Technical product information

Transaction No.: 2035817/1

Water ingress – hood stowage area - high mounted stop lamp

Figure 1

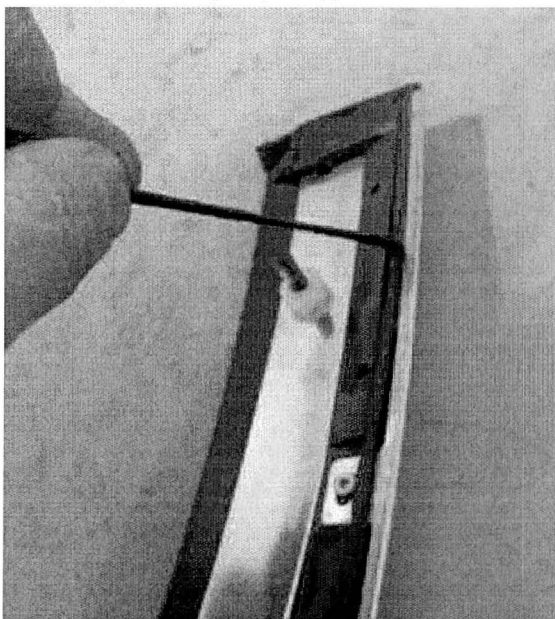
2. Remove the original seal and thoroughly clean the surface on which the new seals will be positioned (see Figure 1)

Figure 2

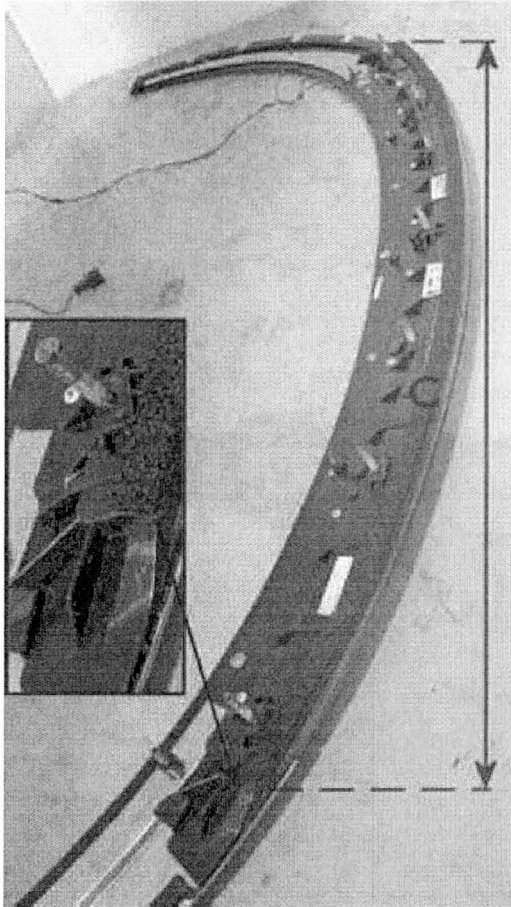
3. Fit new central foam strip (C) part number 3W7854335. Fit this foam strip centrally on the base of the stop lamp housing (see figure 2)

Figure 3

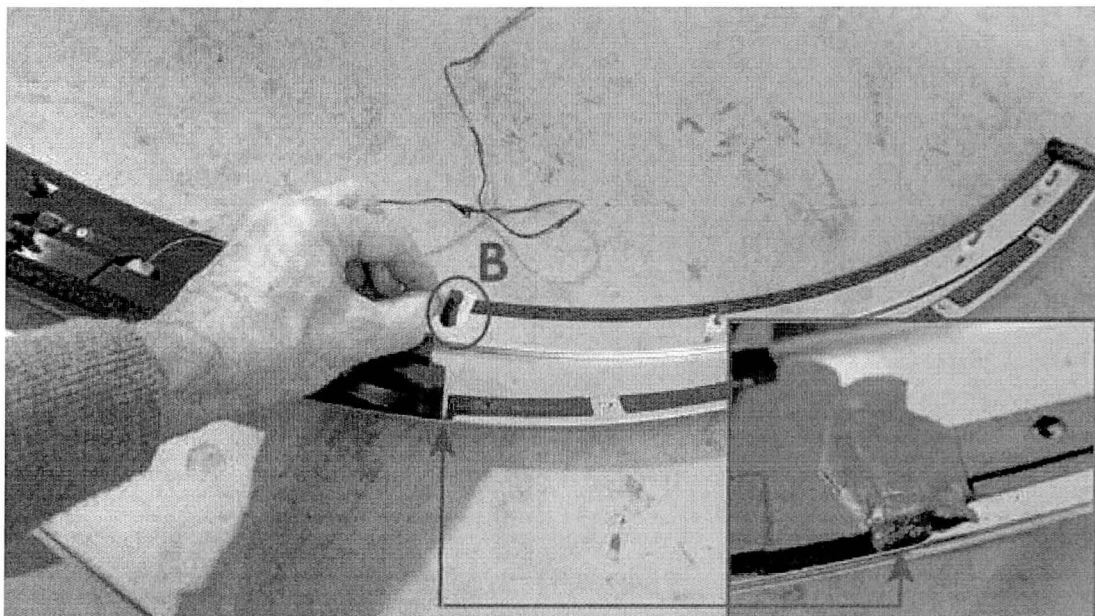
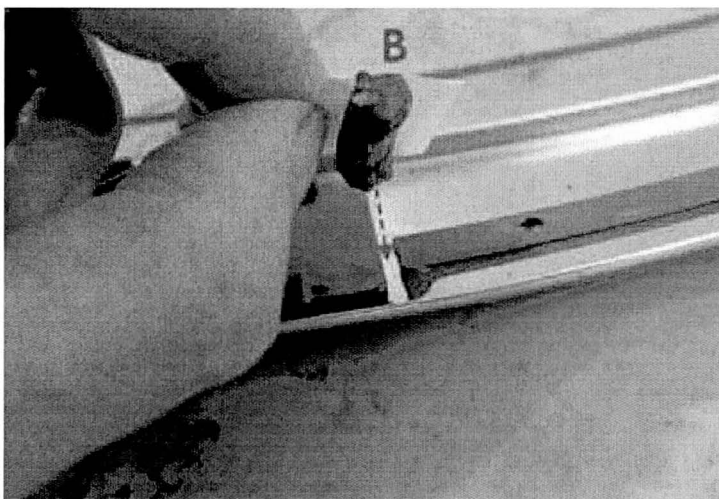
4. Cut two 15mm length of butyl seal from the roll (part number 3W7854546) manipulate these cut lengths of butyl seal (B) into the two slots adjacent to either side of the stop lamp housing to produce a water tight seal and bridge the gap (see Figure 3 and 3a)

Figure 4

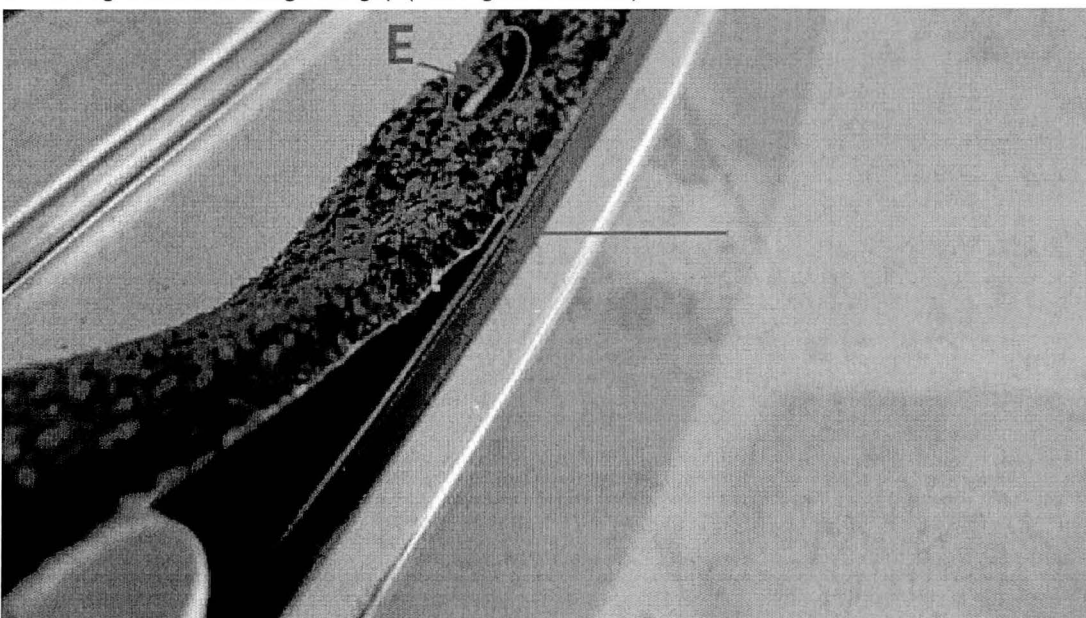
5. Fit the two side seals (D) part number 3W7854336. Align slots (E) cut into this seal with the thread insert in the brightware. Seal (D) should line up with the raised edge of the plastic structure (see arrow Figure 4)

Figure 5

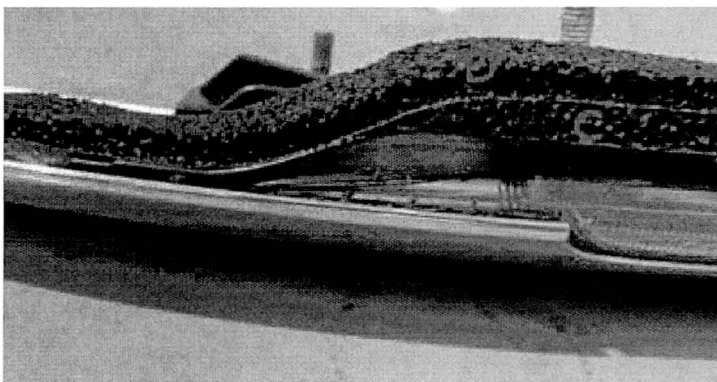
6. Seal D should pass over seal C creating a double seal thickness on the stop lamp moulding (see Figure 5)

Figure 6

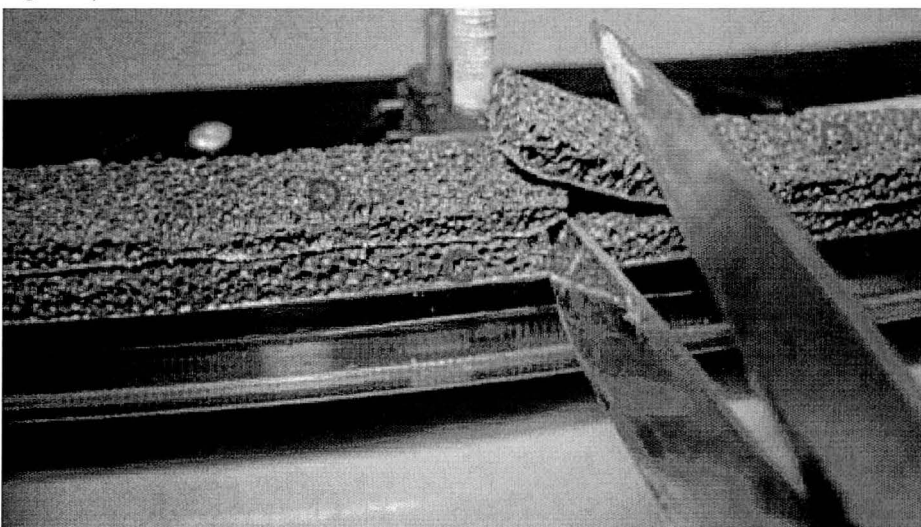
7. Where the two side seals (D) meet in the centre of the assembly cut off the excess to create a butt joint (see Figure 6)
8. Thoroughly clean the tonneau panel prior to refitting the tonneau brightware
9. Refit the tonneau brightware refer to workshop manual Rep.Gr. 66 Brightware/blackware assembly (including stop lamp) To remove and fit
